Access Compliance Report

Public Rights-of-Way

(Curb Ramps)

Intersection ID: 52931	Main Street: WALTHAM_LN	Cross Street: GRAY_OAK_LN	Location:	N
ADA ID: B5FE639A07CB	Ramp Type: Perp	Initial Pass/Fail: Pass	Overall Compliance: No	Severity Score: 0
Codes/Mitigation Info/Possible Solution		Field Measurements/Component Compliance

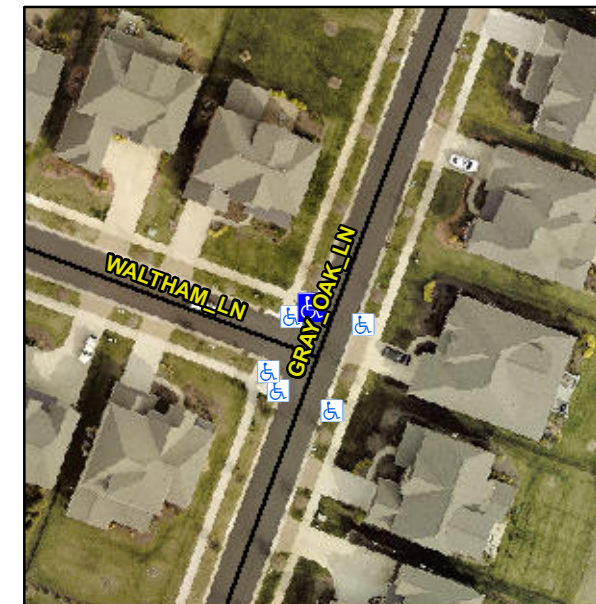
Not Found, R304.5.3, R305.2

Compliance	Description	Data	Compliance	Description	Data
N/A	Ramp Length (in)	96.0	Yes	Ramp Slope (%)	5.1
Yes	Ramp Width (in)	56.0	Yes	Ramp XSlope (%)	0.9
N/A	Flare Type LT	Sloped	N/A	Flare Type RT	N/A
N/A	Flare Slope LT (%)	1.5	N/A	Flare Slope RT (%)	2.4
N/A	Flare Traversable LT?	Yes	N/A	Flare Traversable RT?	No
Yes	Landing Length (in)	60.0	Yes	DWS Provided?	Yes
Yes	Landing Width (in)	56.0	Yes	DWS Contrast?	Yes
Yes	Landing Slope (%)	1.3	Yes	DWS Length (in)	24.0
No	Landing X Slope (%)	3.2	Yes	DWS Full Width?	Yes
N/A	Landing Curb? (Y/N)	No	No	DWS Offset (in)	5.0
N/A	Shared Landing?	No			
Yes	Gutter Ponding?	No	Yes	Gutter Slope (%)	1.4
Yes	Gutter Lip Ht (in)	0.0	Yes	Gutter X Slope (%)	1.7
N/A	Painted X Walk1?	No	N/A	Painted X Walk2?	N/A
	X Walk 1 Direction	To SE		X Walk 2 Direction	N/A
N/A	X Walk 1 Width (in)	N/A	N/A	X Walk 2 Width (in)	N/A
	X Walk 1 Slope (%)	4.0		X Walk 2 Slope (%)	N/A
	X Walk 1 X Slope (%)	2.4		X Walk 2 X Slope (%)	N/A

N/A	Ramp inside XWalk1?	N/A	N/A	Ramp inside XWalk2?	N/A
	Road Slope (%)	N/A	N/A	Clear Space?	Yes
	Road X Slope (%)	N/A	N/A	Clear Space to XWalk (in)	N/A
Yes	Any Obstructions?	No	Yes	Storm Grate/Utility Hazard?	No
	Obstruction Type			Storm Grate/Utility Type	
		N/A			N/A
			Yes	Surface Condition? (G/P)	Good

Remove & Replace Entire Ramp.
